PRODUCT CHANGE NOTIFICATION

Model SRF3225TA-510Y and SRF3225TA-101Y Common Mode Chip Inductors

Design Modification

Existing Core Design	Revised Core Design
Non-shoulder	Core shoulder, one on each end of core

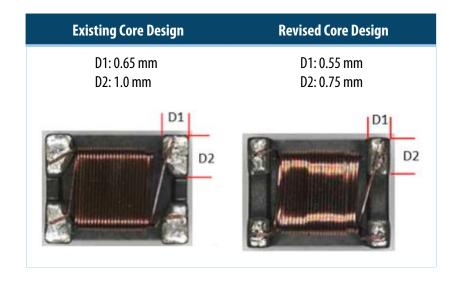
1) Wire channel shoulders added to the inductor core, with one on each end of the core, to channel wire lead from overlapping.

2) Narrower terminal pads.
